UNITED STATES
NUCLEAR REGULATORY COMMISSION
WASHINGTON, D. C. 20555

DONALD C. COOK NUCLEAR PLANT UNIT NO. 1

AMENDMENT TO FACILITY OPERATING LICENSE

Amendment No. 61
License No. DPR-58

Figure 3.2-1 Allowable Deviation from Target Flux Difference

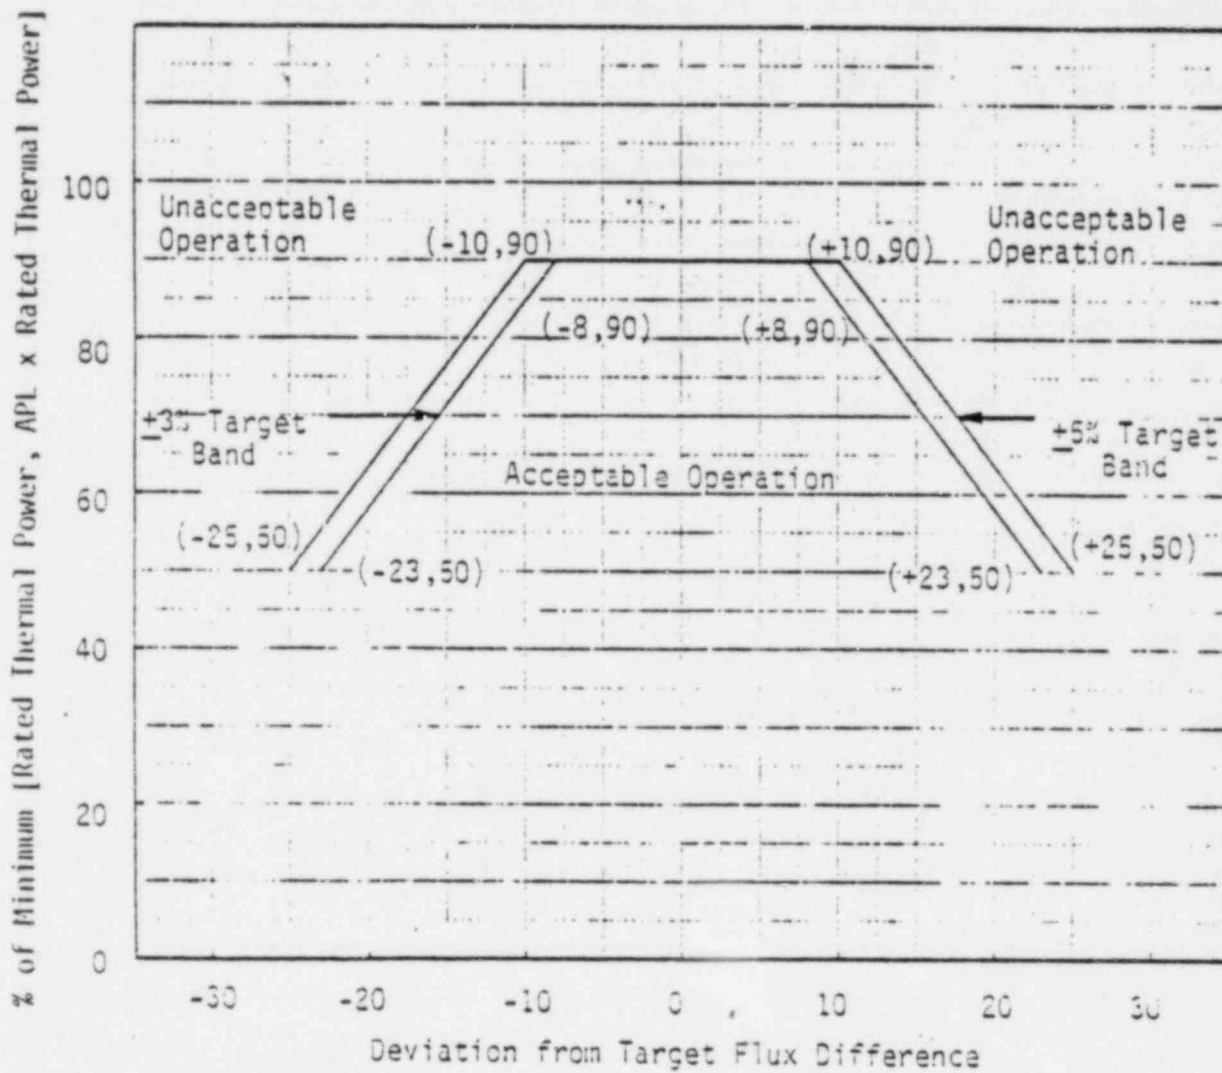
- 2) The indicated AFD is within the limits shown on Figure 3.2-1. Otherwise, reduce THERMAL POWER to less than 50% of RATED THERMAL POWER within 30 minutes and reduce the Power Range Neutron Flux-High Trip Setpoints to $< 55\%$ of RATED THERMAL POWER within the next 4 hours.

- b) Surveillance testing of the Power Range Neutron Flux Channels may be performed pursuant to Specification 4.3.1.1.1 provided the indicated AFD is maintained within the limits of Figure 3.2-1. A total of 16 hours operation may be accumulated with the AFD outside of the target band during this testing without penalty deviation.

- c) Surveillance testing of the APDMS may be performed pursuant to Specification 4.3.3.6.1 provided the indicated AFD is maintained within the limits of Figure 3.2-1. A total of 6 hours of operation may be accumulated with the AFD outside of the target band during this testing without penalty deviation.

Figure 3-2-2 K(Z) - Normalized $F_0(Z)$ As A Function of Core Height

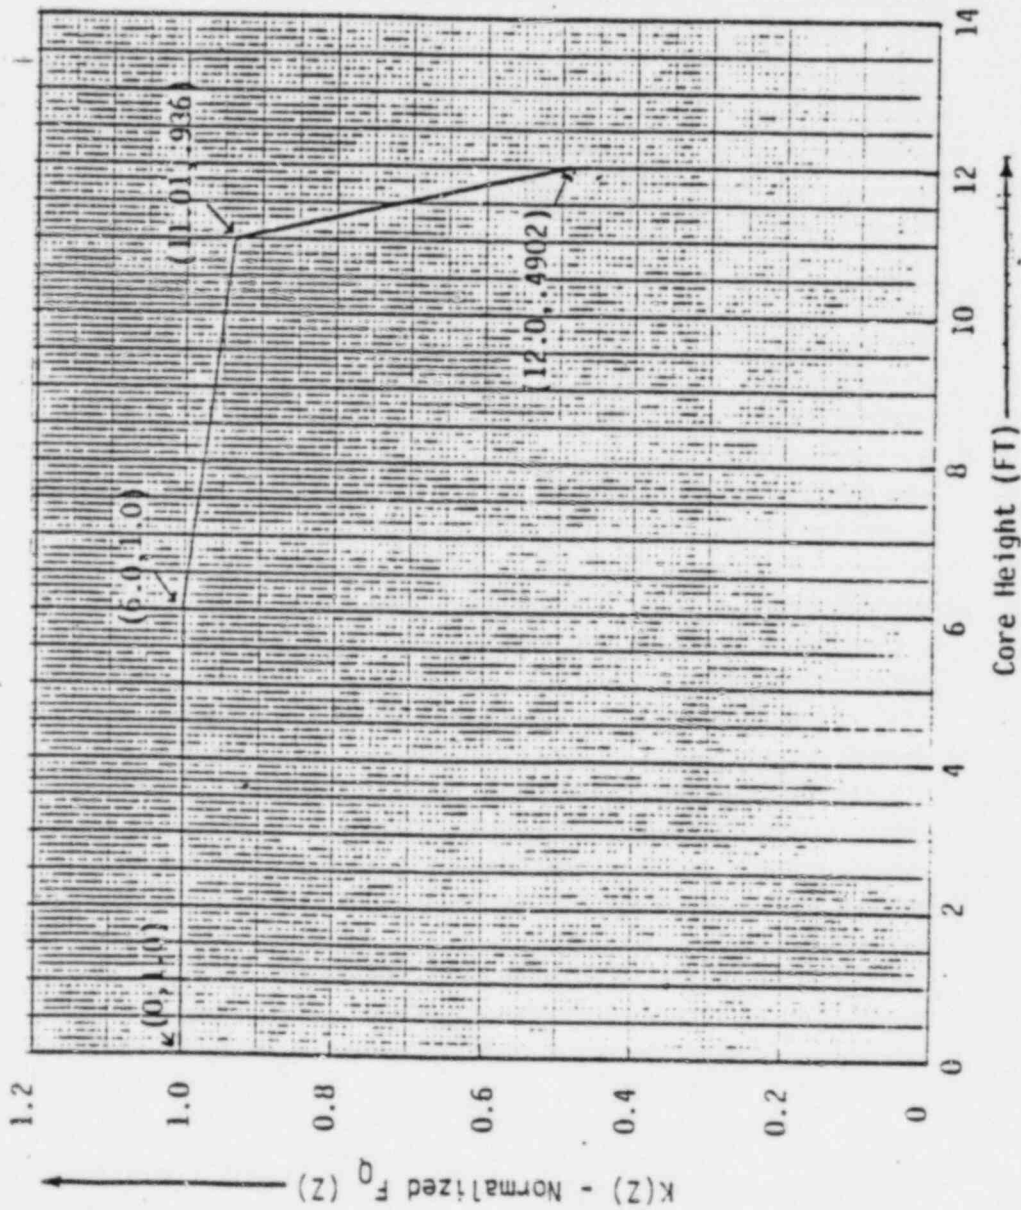
$V(Z)$ is the function defined in Figure 3.2-3 which corresponds to the target band, $K(Z)$ is defined in Figure 3.2-2, $T(E_z)$ is defined in Figures 3.2-3a and 3.2-3b, P is the fraction of RATED THERMAL POWER. $E_P(Z)$ is an uncertainty factor to account for the reduction in the $F_Q^L(E_z)$ curve due to an accumulation of exposure prior to the next flux map.

- a. $F_j(Z)$ is the normalized axial power distribution from thimble j at core elevation Z .
- b. P_L is the fraction of RATED THERMAL POWER.
- c. $K(Z)$ is the function obtained from Figure 3.2-2 for a given core height location.
- d. \bar{R}_j , for thimble j , is determined from at least $n=6$ in-core flux maps covering the full configuration of permissible rod patterns at 100% or APL (whichever is less) of RATED THERMAL POWER in accordance with:

Figure 3.2-3 $V(Z)$ As A Function of Core Height

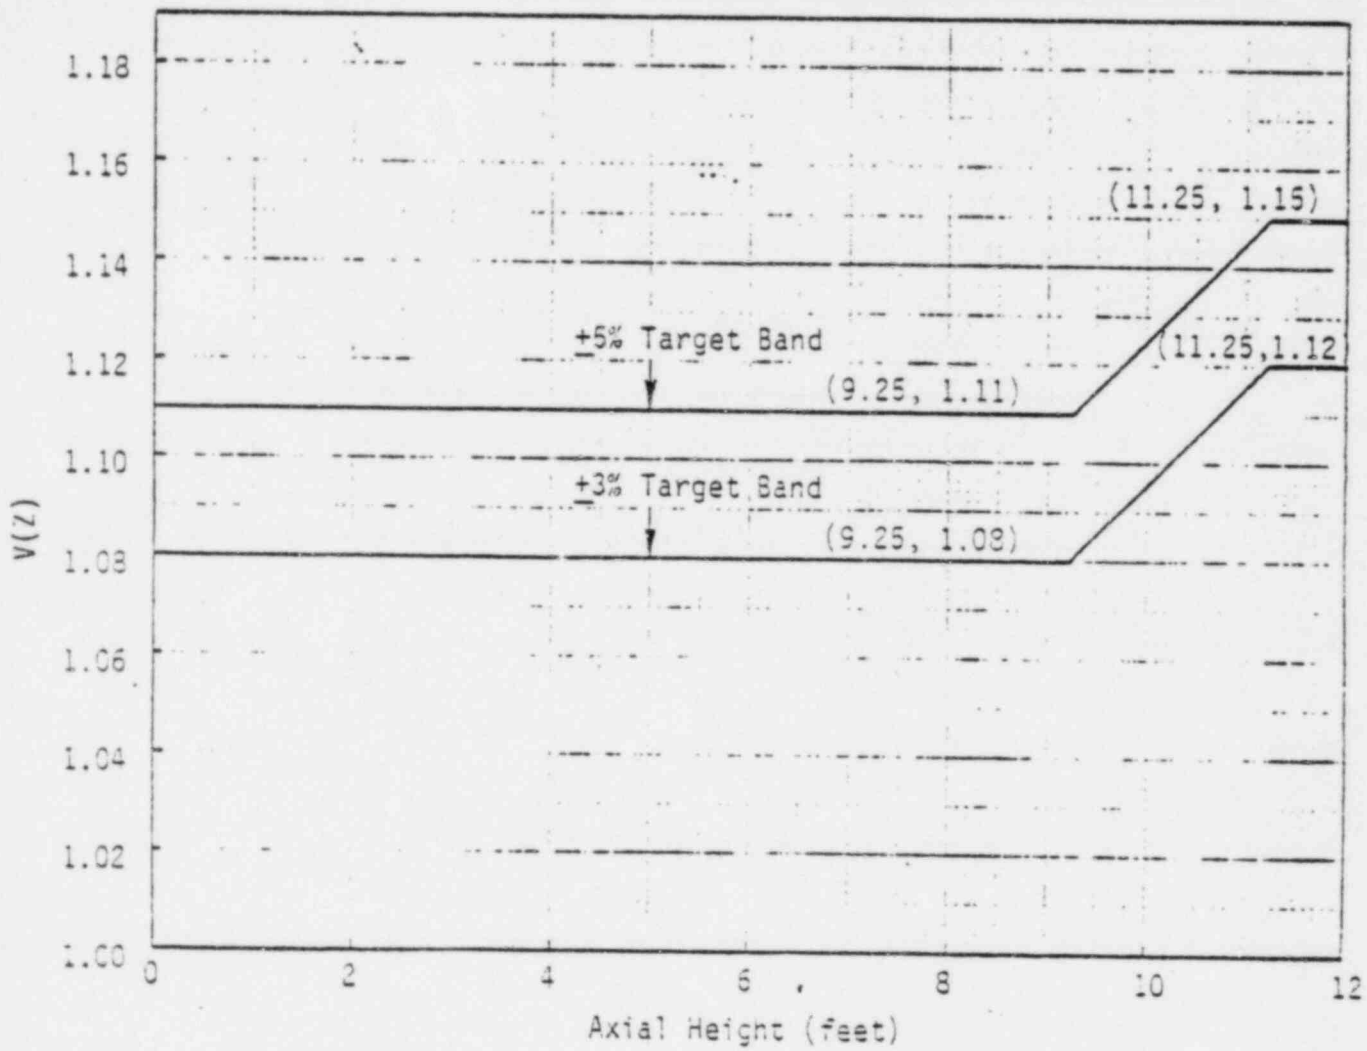
where $F_0(Z,2)$ is the measured $F_0(Z,2)$, including a 3% manufacturing tolerance uncertainty and a 5% measurement uncertainty, at the time of target flux determination from a power distribution map using the movable incore detectors. $V(Z)$ is the function defined in Figure 3.2-3 which corresponds to the target band. The above limit is not applicable in the following core plane region.

Figure 3.2.3a

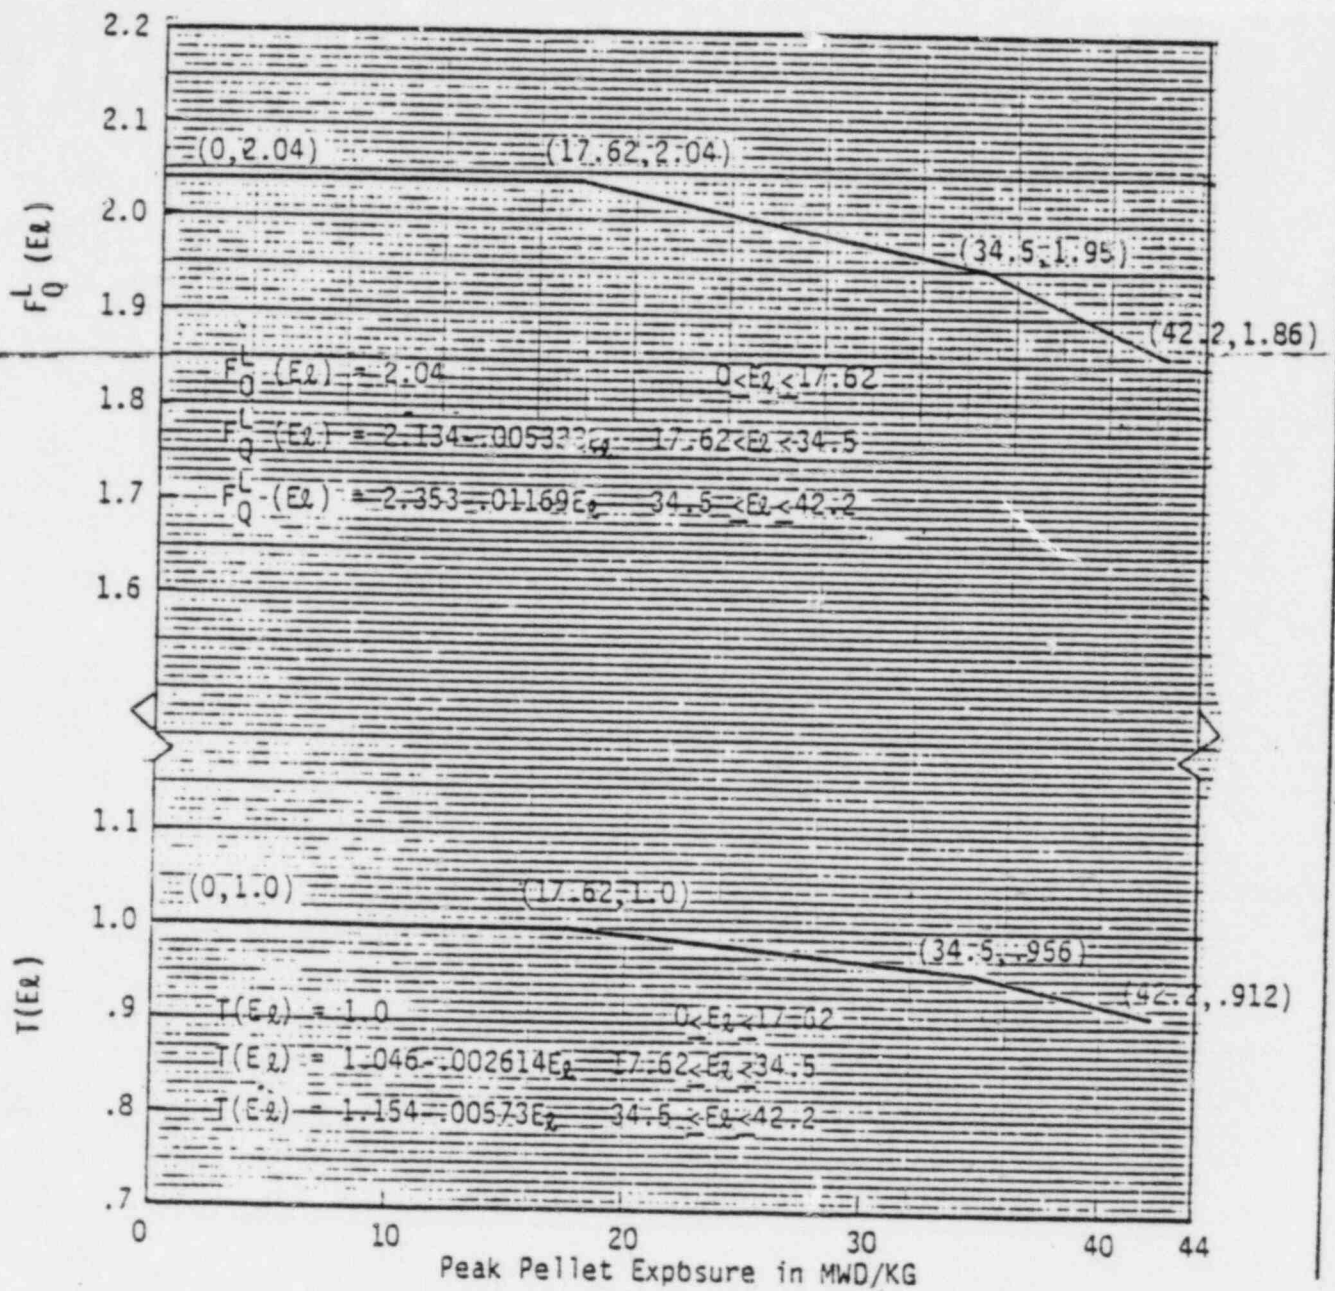
- e. F_{Qiz}^{Meas} is the limiting total peaking factor in flux map i . The limiting total peaking factor is that factor with least margin to the $F_Q^L(Ez)$ curve defined in Figure 3.2-3a for Exxon Nuclear Company fuel and in Figure 3.2-3b for Westinghouse fuel.

$T(E_2)$ is the ratio of the exposure dependent $F_Q^L(E)$ to 2.04 and is defined in Figure 3.2-3a for fuel supplied by Exxon Nuclear Company and in Figure 3.2-3b for fuel supplied by Westinghouse Electric Corporation.

Figure 3.2-1 Allowable Deviation from Target Flux Difference

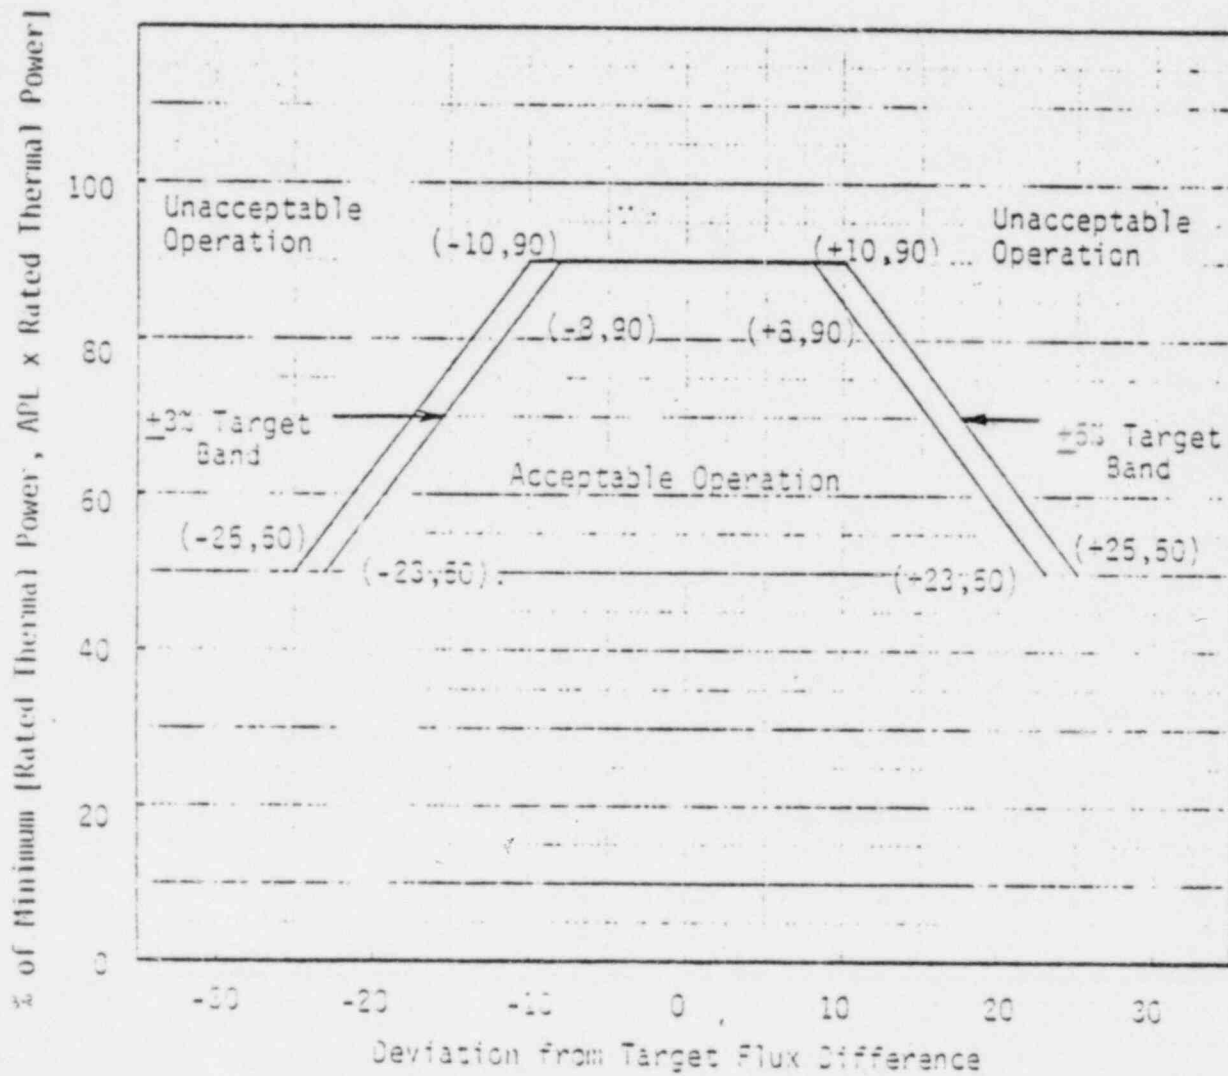
- 2) The indicated AFD is within the limits shown on Figure 3.2-1. Otherwise, reduce THERMAL POWER to less than 50% of RATED THERMAL POWER within 30 minutes and reduce the Power Range Neutron Flux-High Trip Setpoints to $< 55\%$ of RATED THERMAL POWER within the next 4 hours.

- b) Surveillance testing of the Power Range Neutron Flux Channels may be performed pursuant to Specification 4.3.1.1.1 provided the indicated AFD is maintained within the limit of Figure 3.2-1. A total of 16 hours operation may be accumulated with the AFD outside of the target band during this testing without penalty deviation.

- c) Surveillance testing of the APDMS may be performed pursuant to Specification 4.3.3.7.1 provided the indicated AFD is maintained within the limits of Figure 3.2-1. A total of 6 hours of operation may be accumulated with the AFD outside of the target band during this testing without penalty deviation.

Figure 3.7-3 V(Z) As A Function of Core Depth

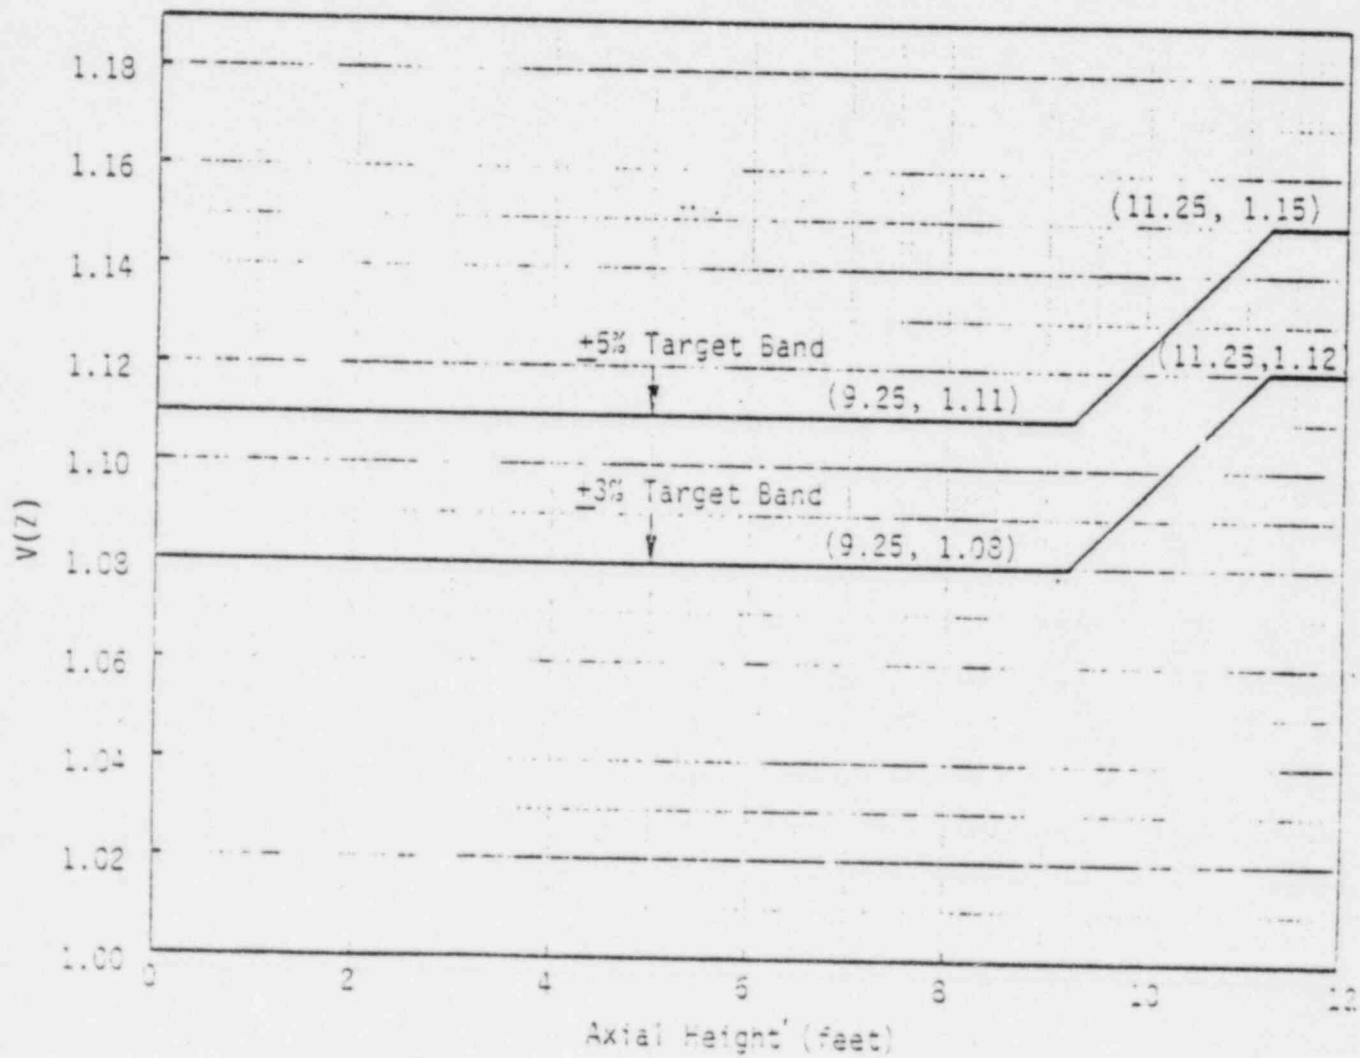
$V(Z)$ is the function defined in Figure 3.2-3 which corresponds to the target band, $K(Z)$ is defined in Figure 3.2-2, P is the fraction of RATED THERMAL POWER.

where $F_Q(Z)$ is the measured $F_Q(Z)$, including a 3% manufacturing tolerance uncertainty and a 5% measurement uncertainty, at the time of target flux determination from a power distribution map using the movable incore detectors. $V(Z)$ is the function defined in Figure 3.2-3 which corresponds to the target band. The above limit is not applicable in the following core plane regions.
